Wednesday 8<sup>th</sup> January, 2020

**Re: Product Change Notification for Harwin packaging.**

*Left = New plastic cap, Right = Previous metal cap*

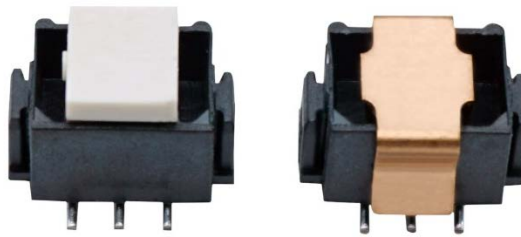
Please be advised that the pick and place cap used on male Datamate connectors (M80 Series) has been changed from a metal stamped cap to a plastic cap. This has been identified and implemented as part of our continuous improvement program at Harwin. The visual difference is as follows:

As you can see from the profile of the plastic cap, a small amount of additional height has been introduced, and changes to the settings on your pick and place machines may be required. Please also note, we use a selection of materials for the plastic cap which will result in either natural or black plastic, depending on availability.
